# HARTING Product Change Notification

**PCN/19/029/C+N**

**Title:** Dimension change of Han 16B and Han 24B hood - External

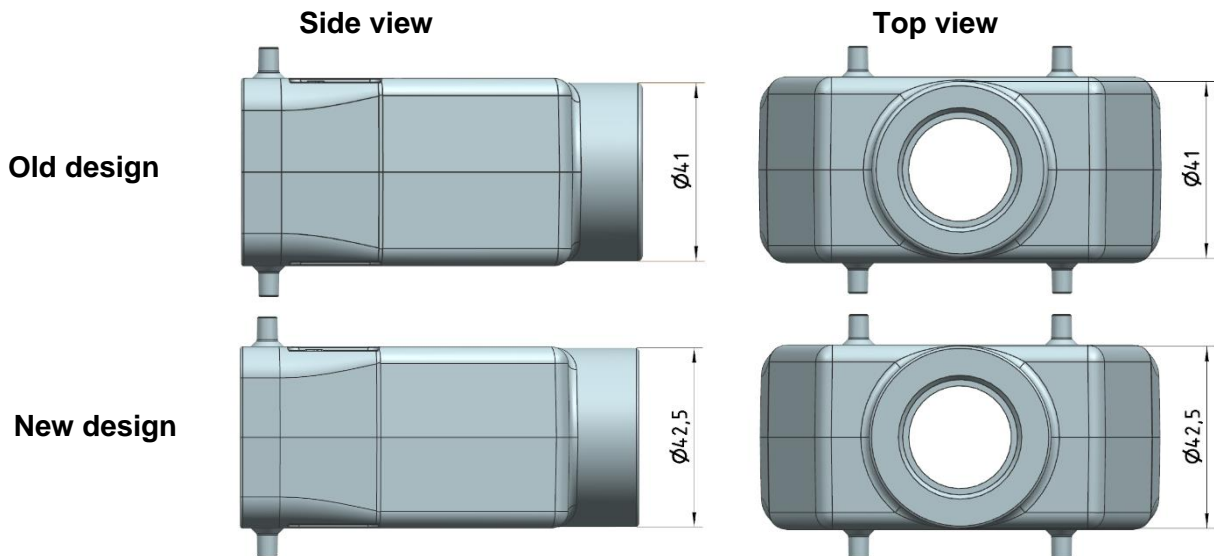
The dimension of the socket will be changed from 41 mm to 42,5 mm. We implement the change to offer more bearing surface for the cable gland.
